Redevelopment Agency Work Session Notice

## **REVIEW OF PROPOSED FIRST AMENDMENT TO THE MIXED USE ZONE MASTER DEVELOPMENT AGREEMENT (MUMDA) FOR PHASE 1 OF THE OGDEN BEND MASTER PLANNED COMMUNITY**

**DATE:** January 15, 2016  
**TO:** Ogden City Redevelopment Agency  
**THRU:** Mark Johnson, CAO  
**FROM:** Tom Christopoulos, CED Director  
**RE:** Amendment to Ogden River Bend Phase 1 exhibit for townhome building elevations at 267-277 Park Boulevard.  
**STAFF CONTACT:** Greg Montgomery, Planning Manager

**Agenda Name: Amendment to Ogden River Bend Phase 1-Townhome building elevations at 267-277 Park Boulevard**

AMENDED PHASE 1 BUILDING USE PLAN

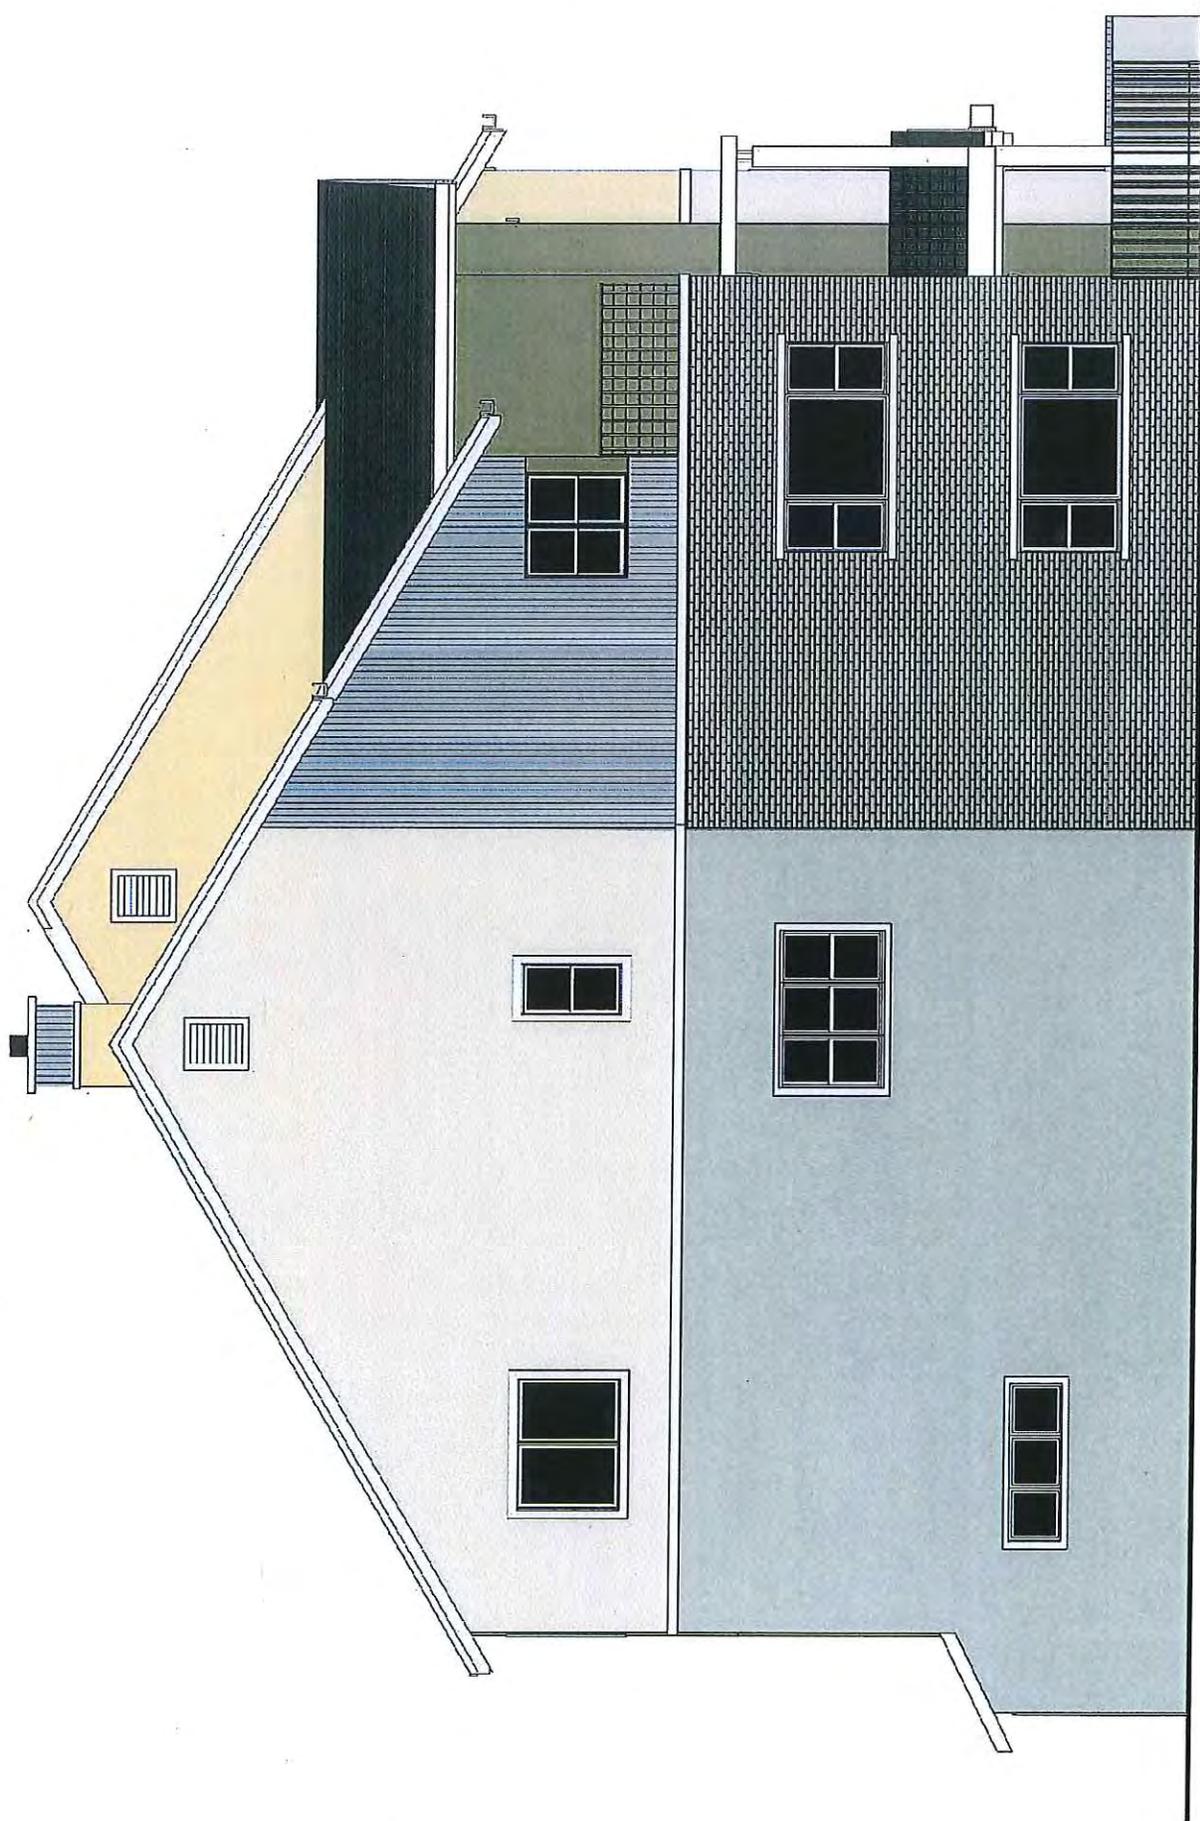
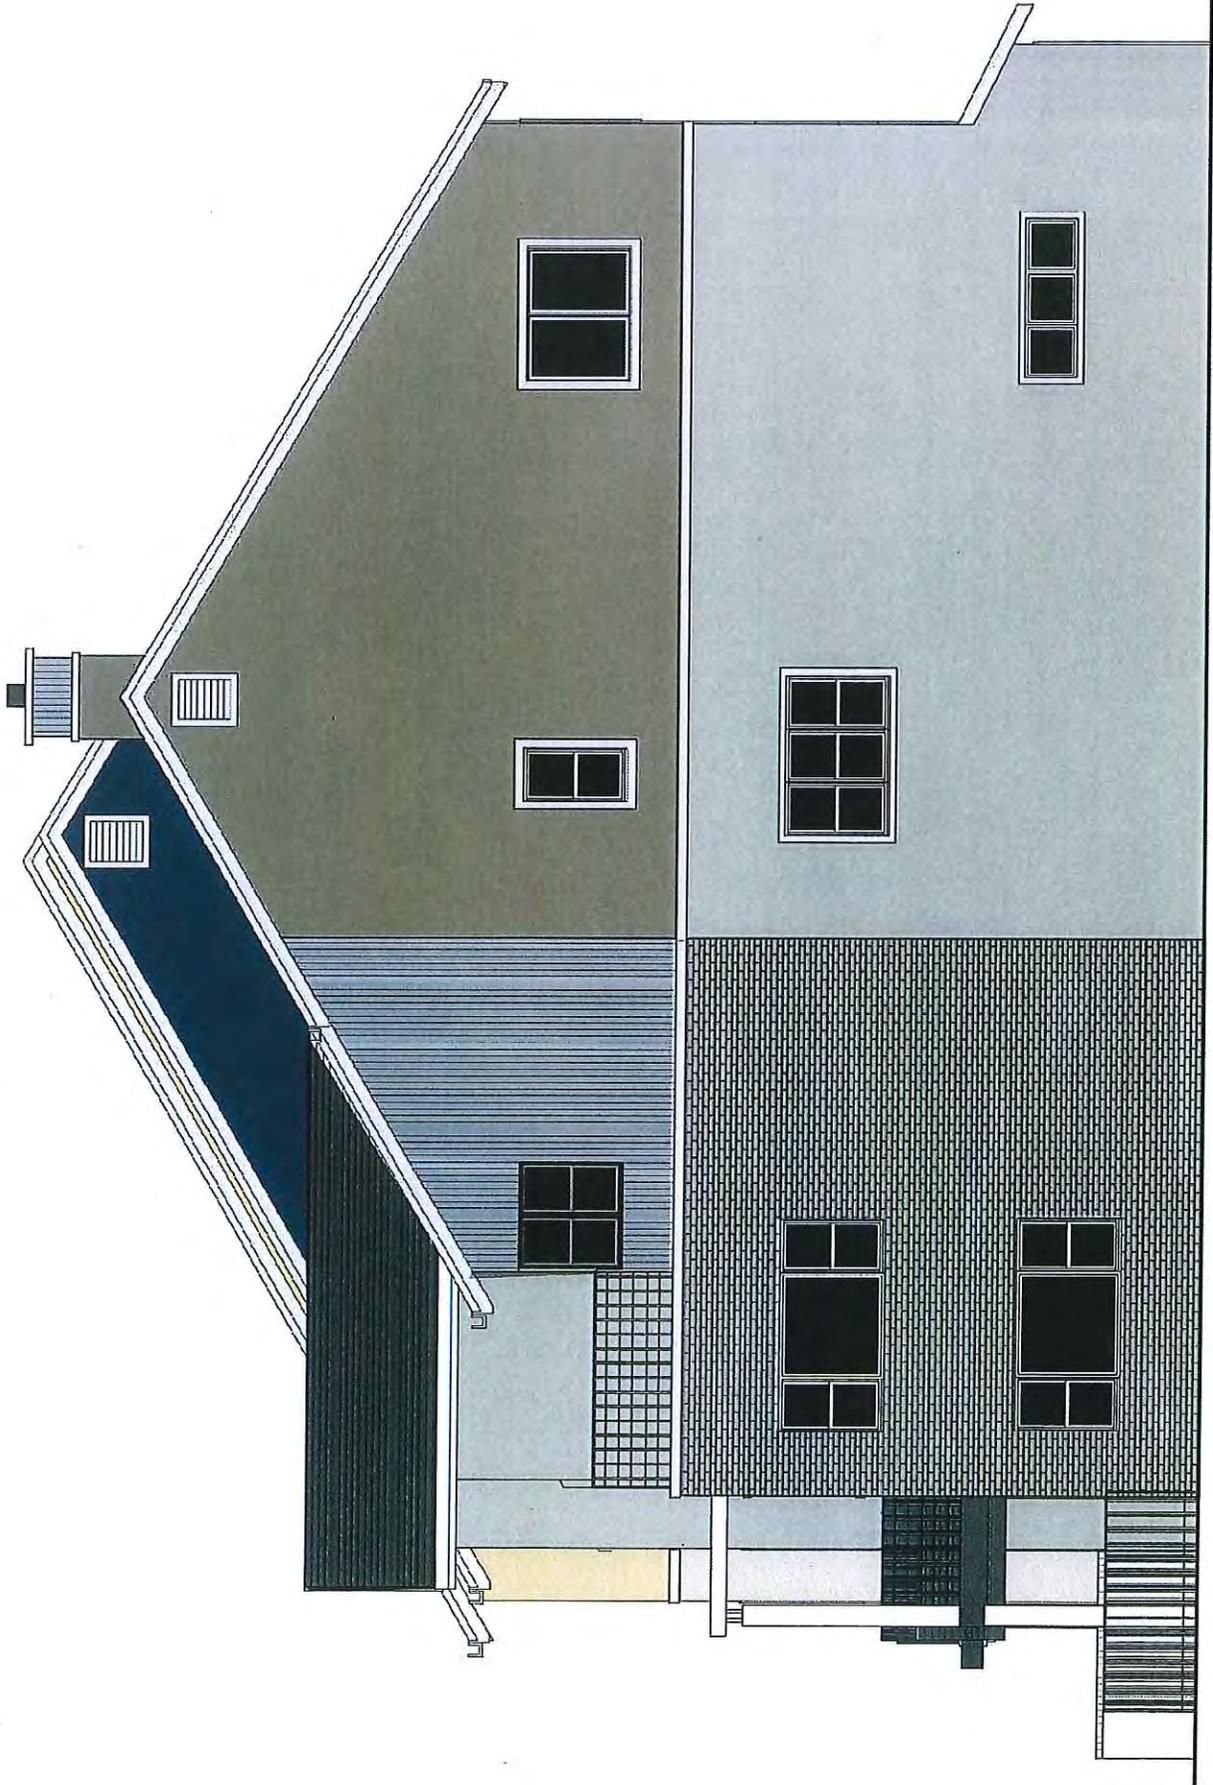
2. *Project Development Standards*: Pages 153-154 of the approved Building Use Plan for Phase 1 of the Ogden Bend Master Planned Community are hereby replaced and superseded in their entirety to allow the construction of townhome units with the dimensions and exterior architectural elevations as shown on **Exhibit A** (Amended Phase I Building Use Plan) attached hereto, and incorporated herein by reference
